# Service Manual

*Supplement*

**KX-TS2388CAB/KX-TS2388CAW/  
KX-TS2388RUB/KX-TS2388RUW/  
KX-TS2388UAB/KX-TS2388UAW/  
KX-TS880B/KX-TS880W/  
KX-TS880LXB/KX-TS880LXW/  
KX-TS880MLW/KX-TS880MXB/  
KX-TS880MXW/KX-TS880NDB/  
KX-TS880NDW/KX-TS880SAW/  
KX-TS881MXB/KX-TS881MXW/  
KX-TS889MXW/KX-TS108W**

Integrated Telephone System

KX-TS880/881/889/2388 CIRCUIT BOARD (Main (Bottom View))

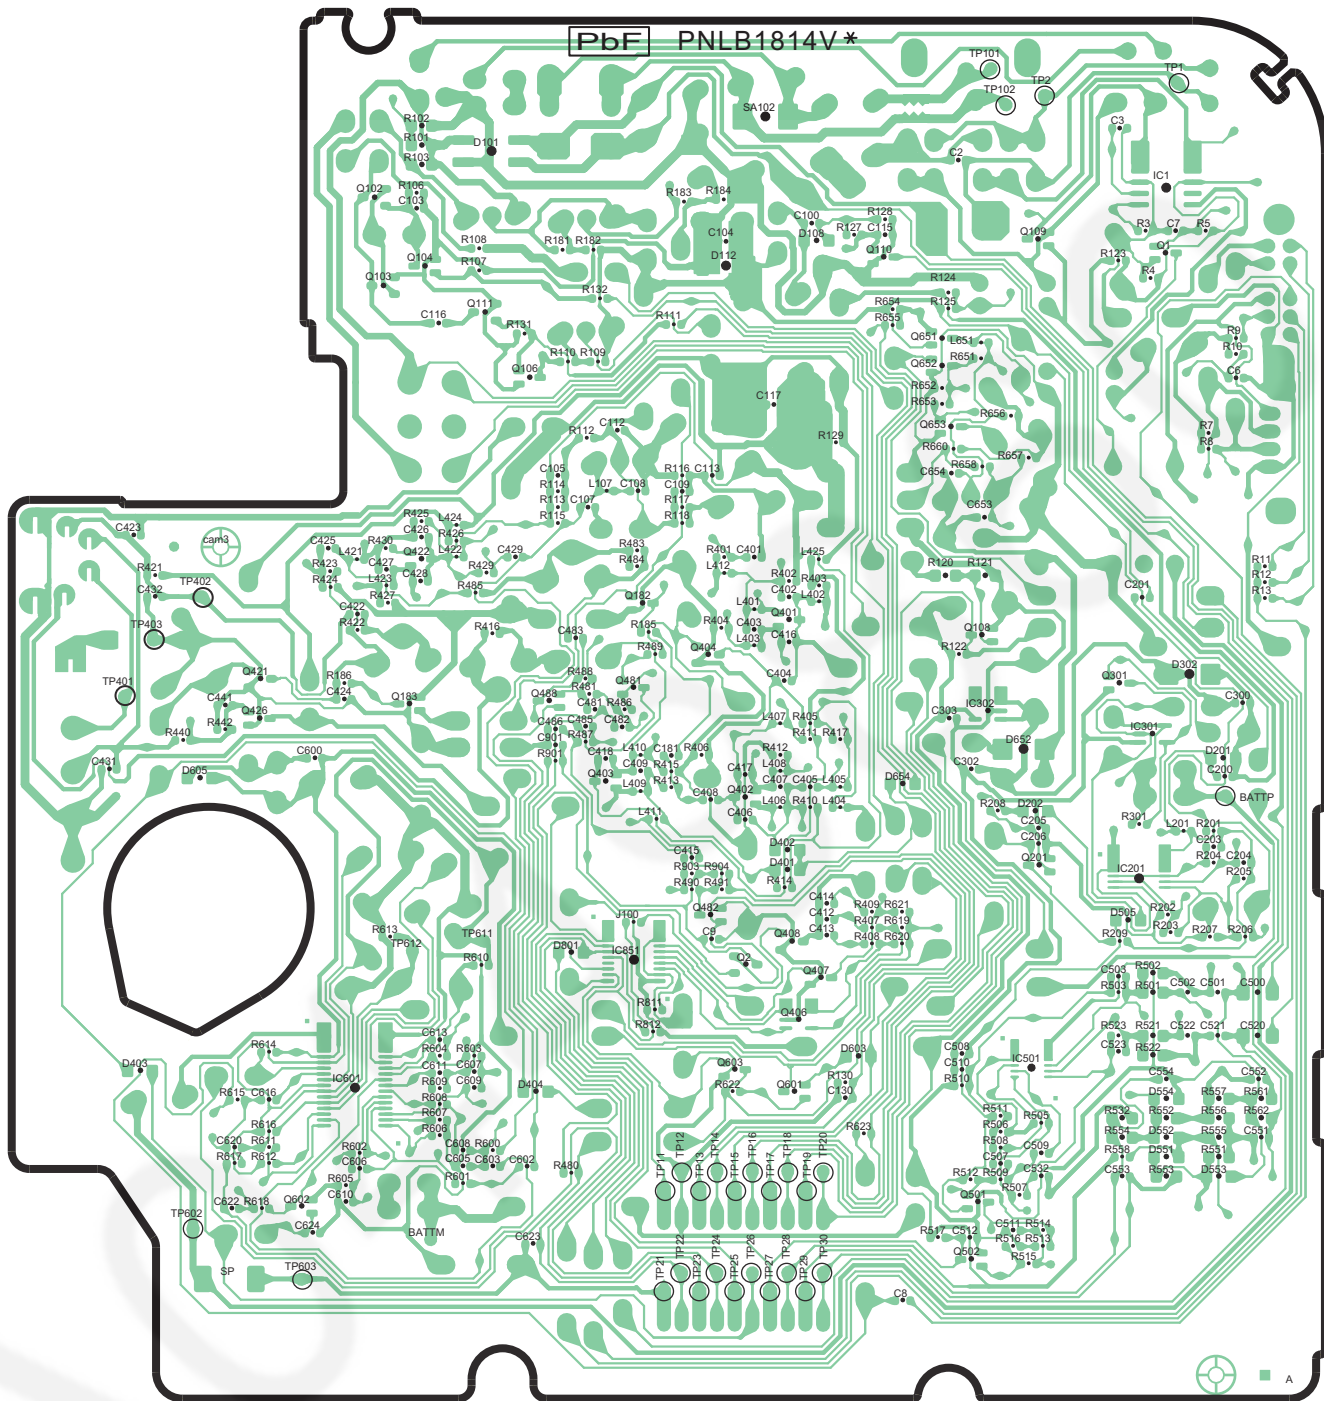
[Changed from original section "12.1.2. Bottom View"]
